1601 - John Street

Address: 17 John Street, London, WC1N 2DE

Ref: PP-06010813

Please see notes and images below in respect to comments and questions received, 01/08/17, from the Hertiage and Conservation Officer.

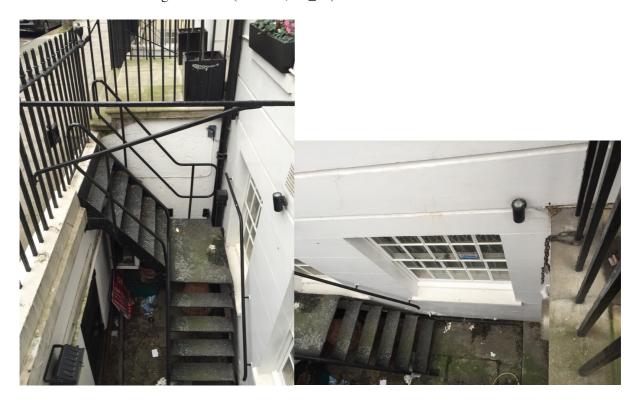
Above and Left: Existing unsightly AC units and feeds located on rear façade are to be removed (outlined in red)

Proposed AC provision has been designed to allow for the complete removal of all unsightly existing AC units and ductwork on rear façade. New AC condenser units will be positioned in valley of roof not visible from street level or rear of property, and within new terrace planter, and without ducts or pipes visible on rear façade. (See drawings PL-03, PL-04 and PL-05)
